RFP Title: Site Improvements at Gano Street Park

Addendum #: 1

SITE IMPROVEMENTS AT GANO STREET PARK

November 13, 2024

SHEET TITLE

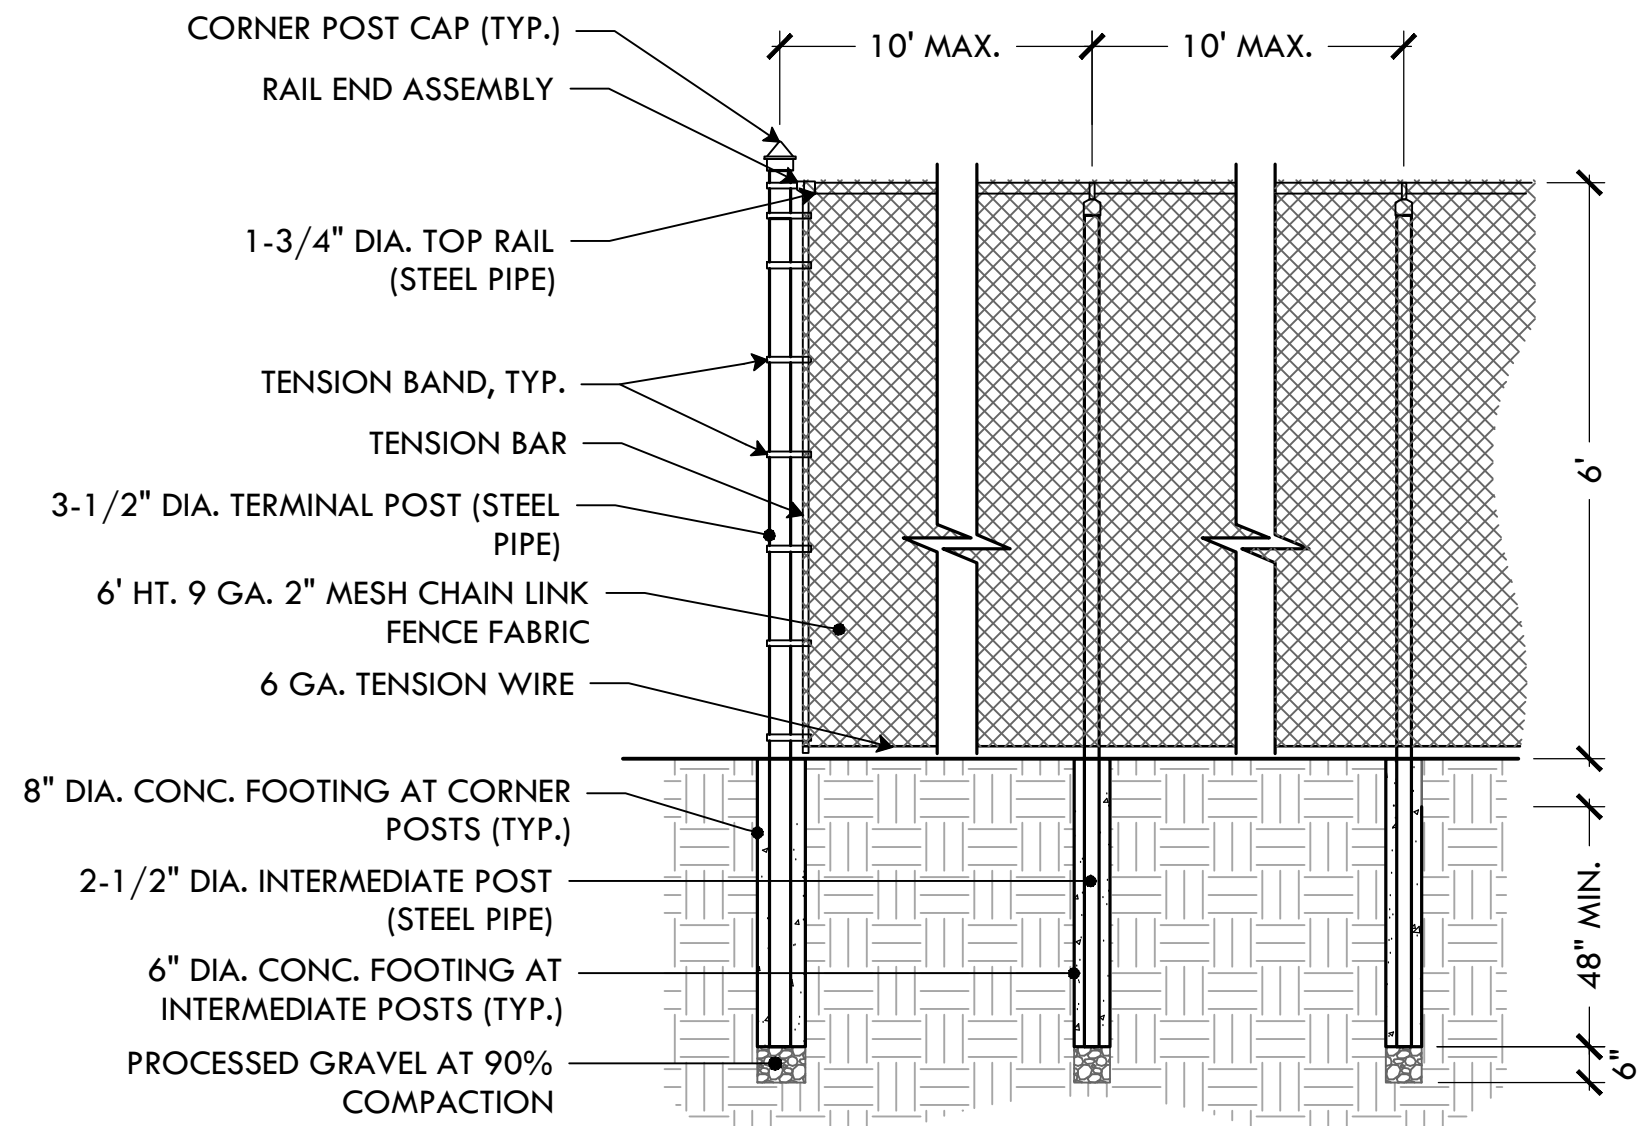
1. RFP p. 41, item #38 has been amended.
2. RFP p. 45, Drawings sheet schedule has been updated to reflect total number of sheets of lighting plans.
3. Technical Specifications for Site Furnishings have been updated to include dugout player's bench specifications.
4. Revisions made on plan set including sheets L-1, L-6, L-9, L-10, and L-11.
